UPPER MORELAND TOWNSHIP

Regular Meeting

September 14, 2020 at 7:00 p.m.

LAYOUT PLAN

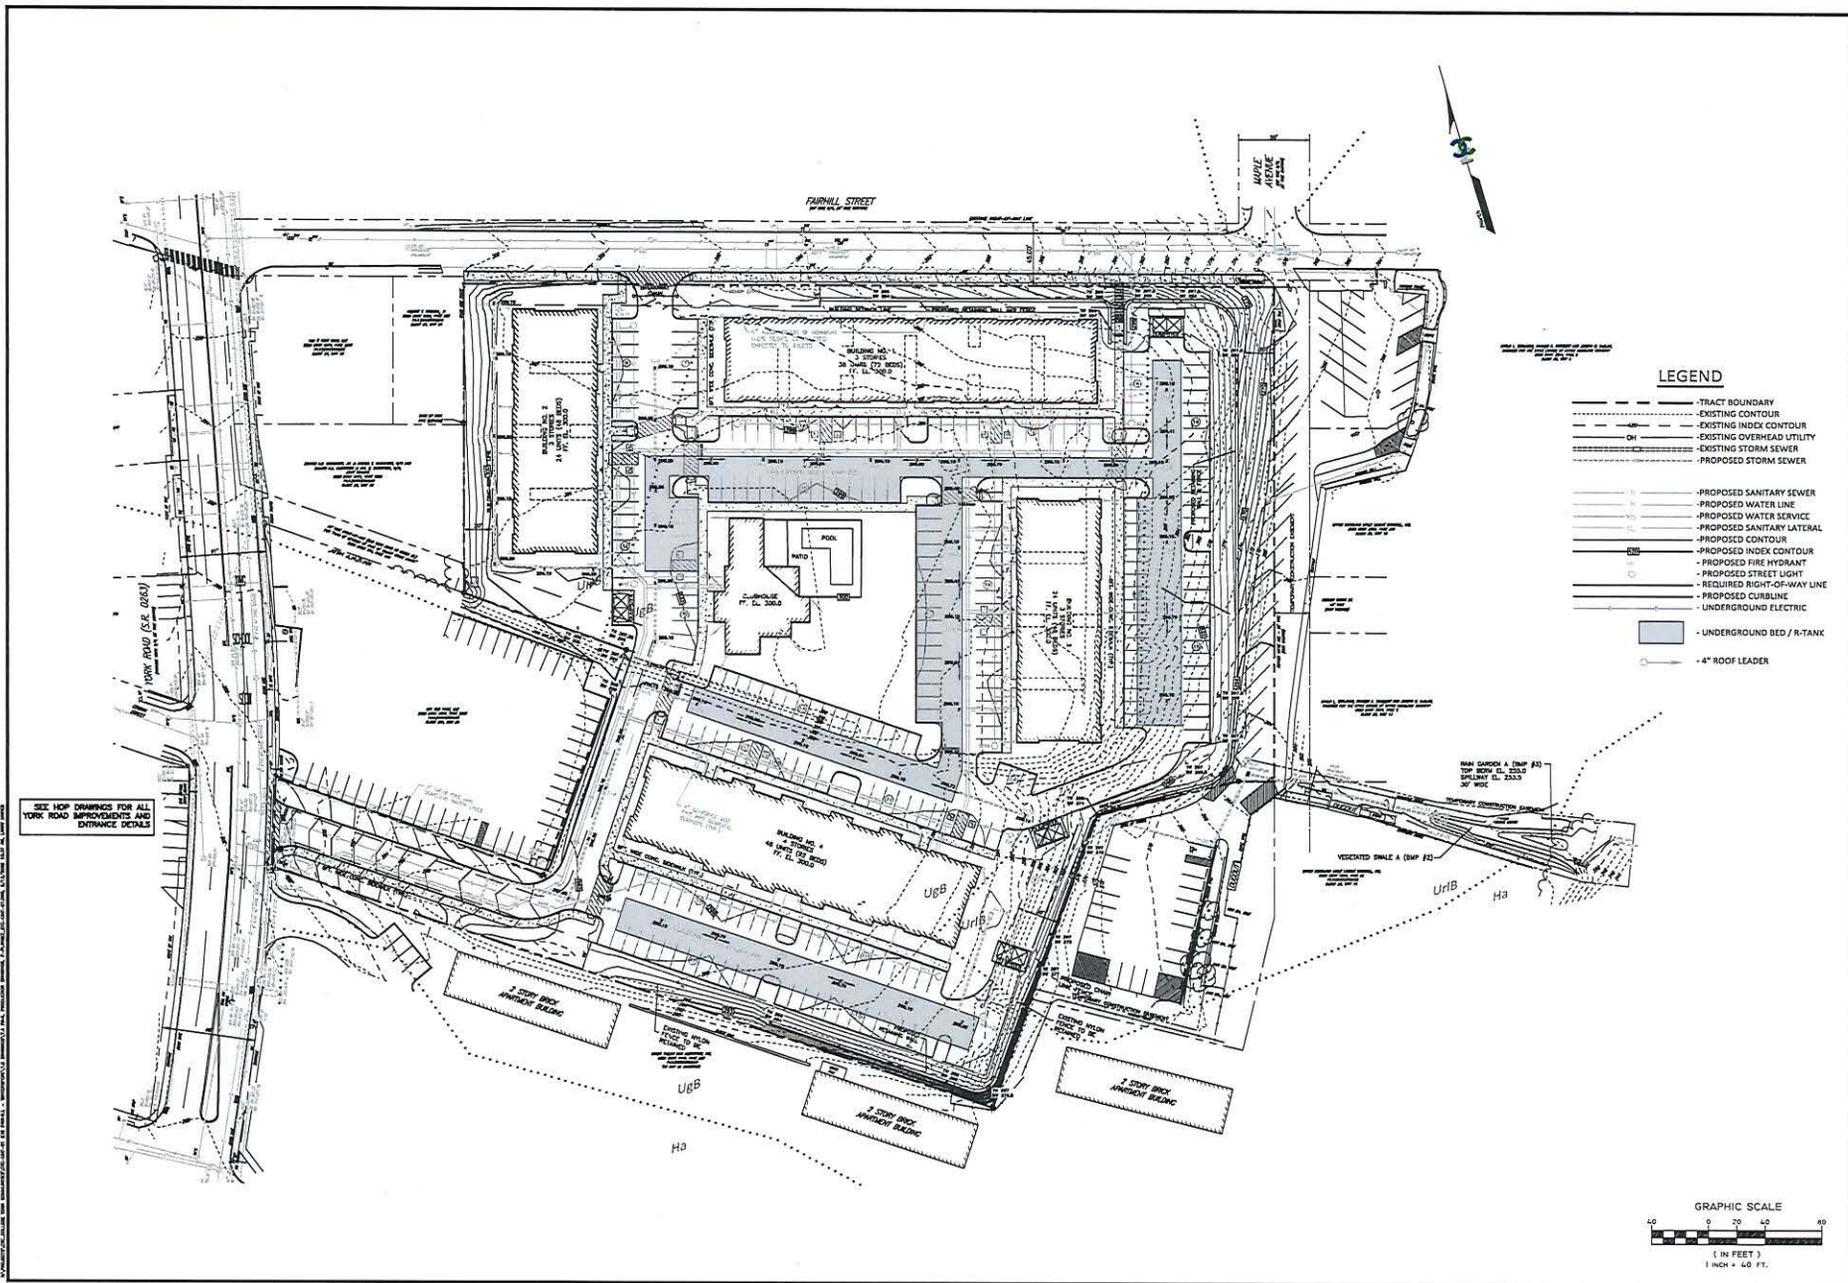
14. §300-52.C(2) – The Layout Plan, Sheet 3, should be revised to show both the existing legal right-of-way and proposed ultimate right-of-way for Fairhill Road and York Road (S.R. 0263). The areas between the legal and ultimate rights-of way that are to be offered for dedication to the governing body having jurisdiction should be clearly depicted on the plan.

UTILITY PLAN
C2C DESIGN GROUP
 37 East Penn Avenue
 Suite 200
 P.O. Box 1000
 York, PA 17402
 www.c2cgroup.com

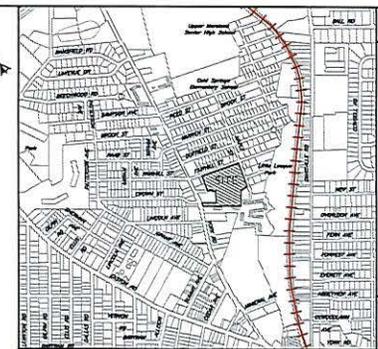
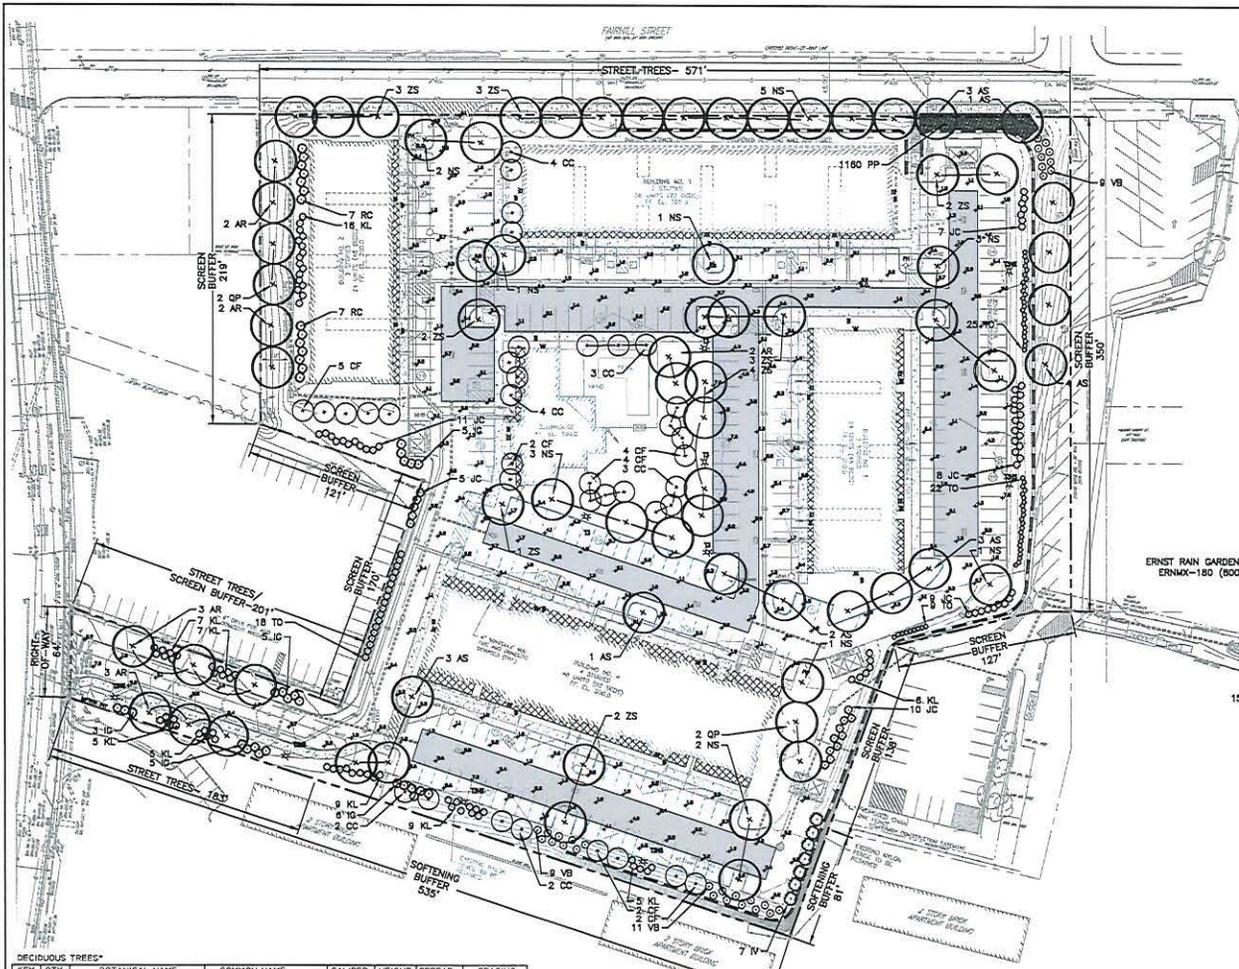
15. §300-52.D(5) – The location, size, and material of all proposed utility connections, including gas and electric services should be added to the Utility Plan, Sheet 5.

LANDSCAPE & LIGHTING PLAN

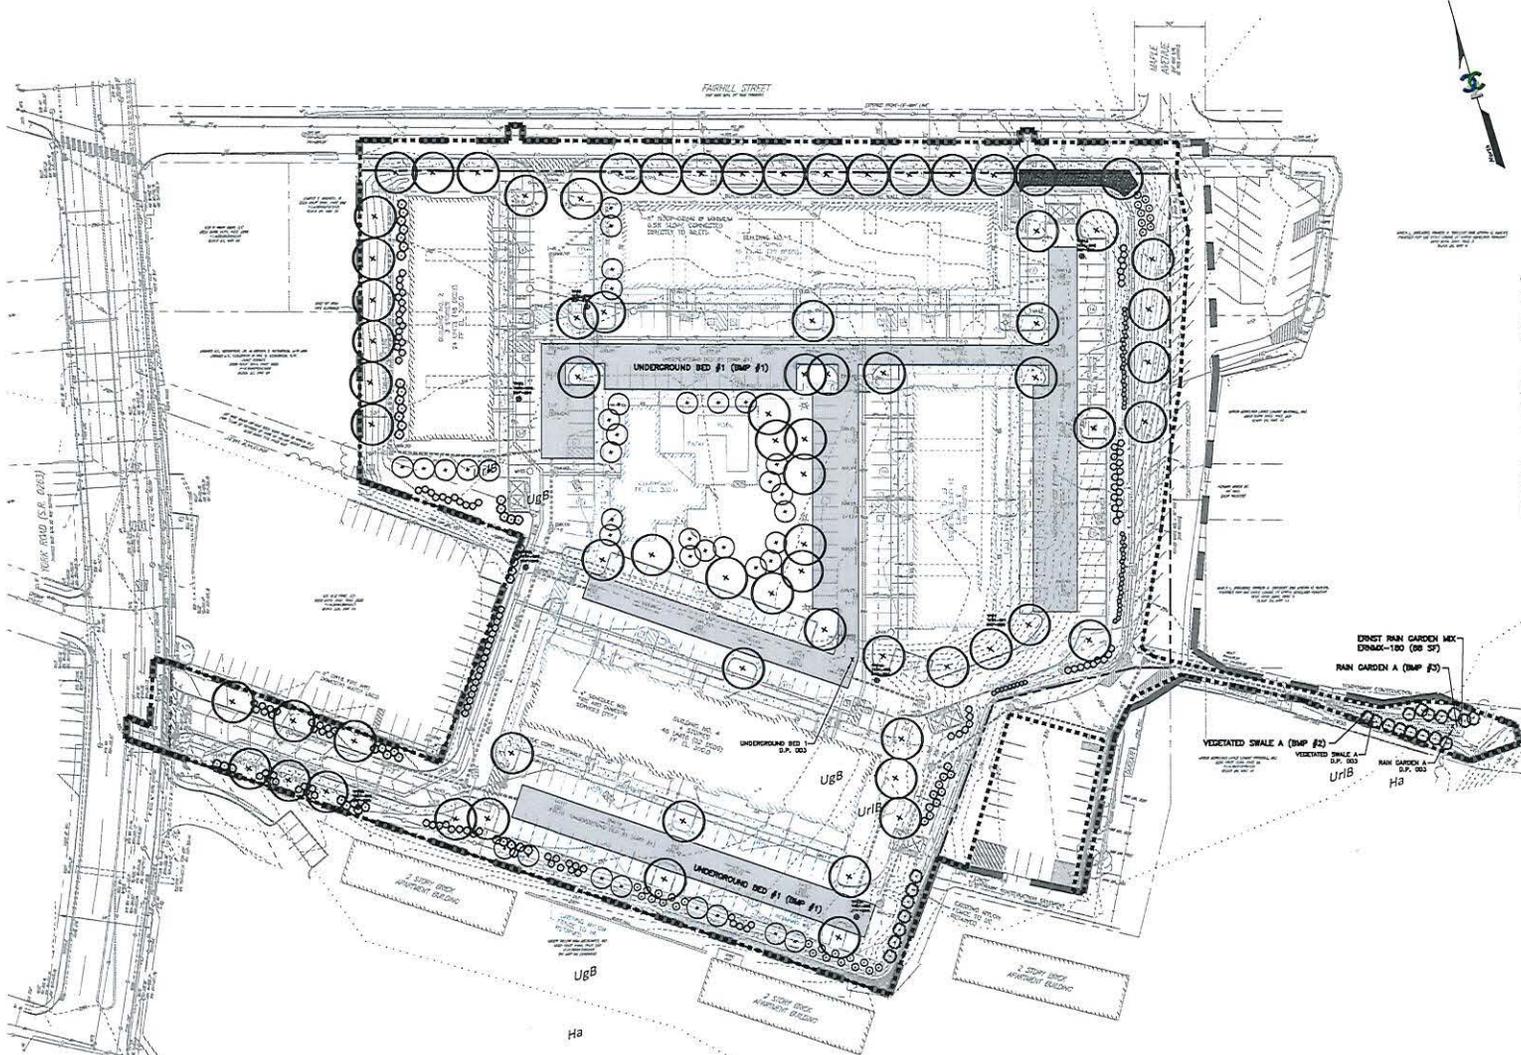
25. The plans include two separate Luminaire Schedules on the Landscape & Lighting Plan, Sheet 6, and the Construction Details, Sheet 11. The schedules should be revised to correlate with one another. In addition, we recommend the proposed lights on the Landscape & Lighting Plan, Sheet 6, be labeled in accordance with the Luminaire Schedule for clarity.

- The waiver request letter indicates 173 replacement trees are required. Based on the “Replacing Trees Destroyed by Development” chart on Sheet LL-1, we offer the following further breakdown (which we recommend is clearly outlined in the chart):

STORM SEWER PROFILES
C2C DESIGN GROUP
 27 EAST PENNA AVENUE
 SUITE 100
 HARRISBURG, PA 17104
 WWW.C2CGROUP.COM

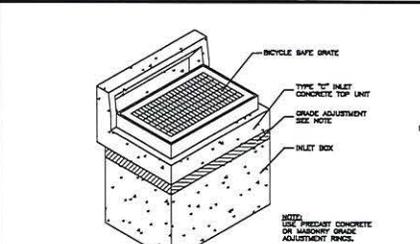
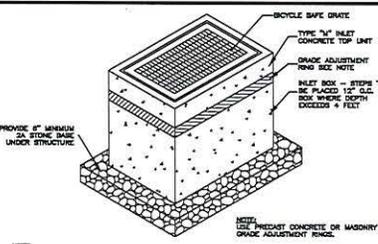
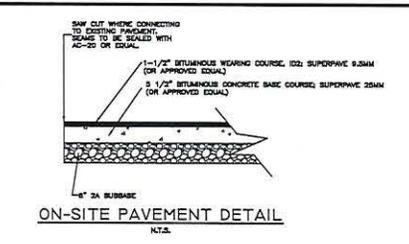
2. 287-18.S – We note the following discrepancies between the Storm Sewer Tabulation Profiles located on Sheet 10:
 - a. MH28 – RIM elevation.
 - b. UGB1 – The RIM elevation should be set at 294.84.

CONSTRUCTION DETAILS
2255 WYANDOTTE ROAD
UPPER MERICAN TOWNSHIP
MONTGOMERY COUNTY, PA
Prepared by
JULH - WR LLC

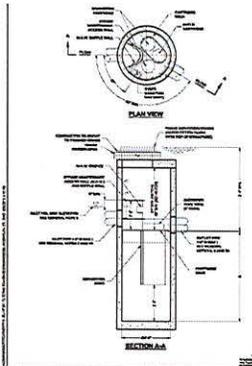
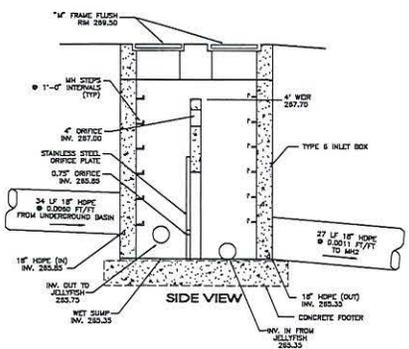
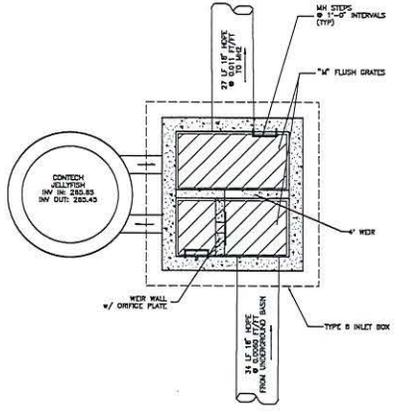
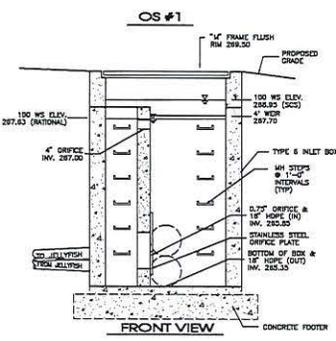
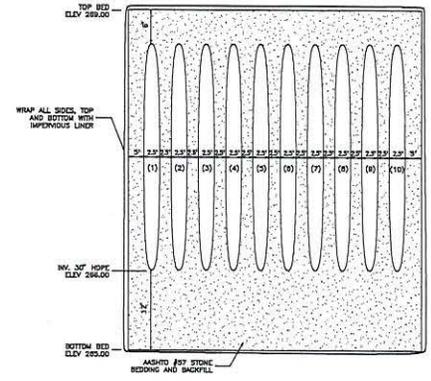
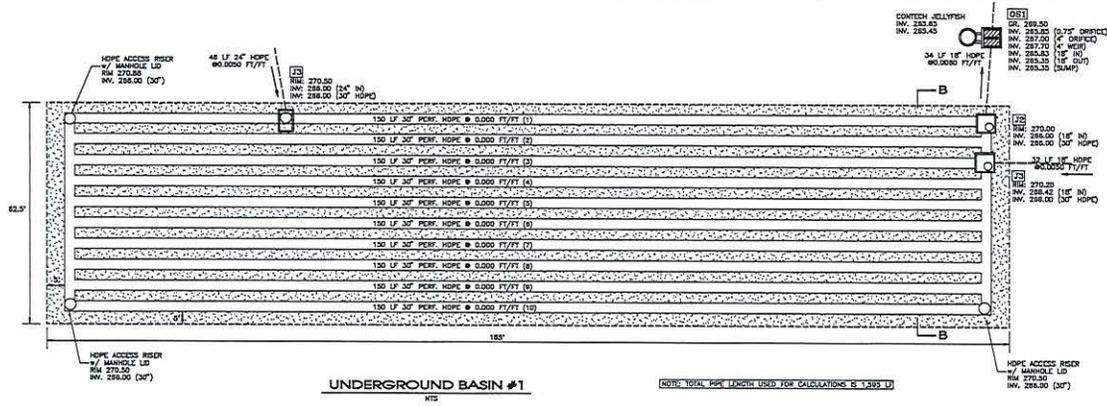
15. The front, side and plan views of Outlet Structure OS#1 shown in the detail on Sheet 13 do not appear to be consistent in identifying the location of the orifice and weir openings in relation to the jellyfish filter and the outlet pipe. The detail must be revised to clearly show if both orifices and weir openings drain through the jellyfish filter or if orifice/weir bypasses the filter at the higher elevations.
